Service Bulletin

Subject: Fenwal Dual Spark Ignition Module

Models: Non-CE FPPH55 Full Vat Fryers

5/7/2026

Figure 1

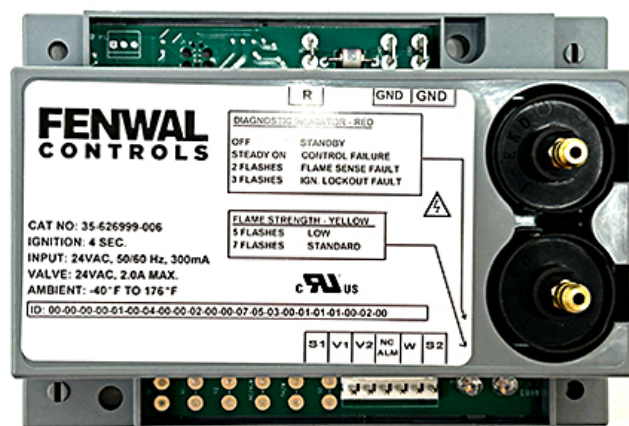
Beginning in February 2024, Frymaster reintroduced dual spark ignition modules for **NON-CE H55 FULL VAT FRYERS ONLY**. This allows a single dual spark module to operate both sides of the H55 full vat fryer.

This new single Fenwal dual spark module, eliminates the need for two single spark modules for Non-CE H55 full vat fryers, manufactured with serial numbers beginning 2402 and later.

The part number for the new dual spark module is PN 130208190. The ignition harness for this module is PN 8076651. Please order sufficient stock to support any H55 full vat fryers in your area.

This dual spark module **DOES NOT** replace single spark modules currently installed on fryers in the field. It should **ONLY** replace existing failed dual spark modules, installed in full vat H55 fryers manufactured with serials beginning 2402 and later, which have the dual spark module installed.
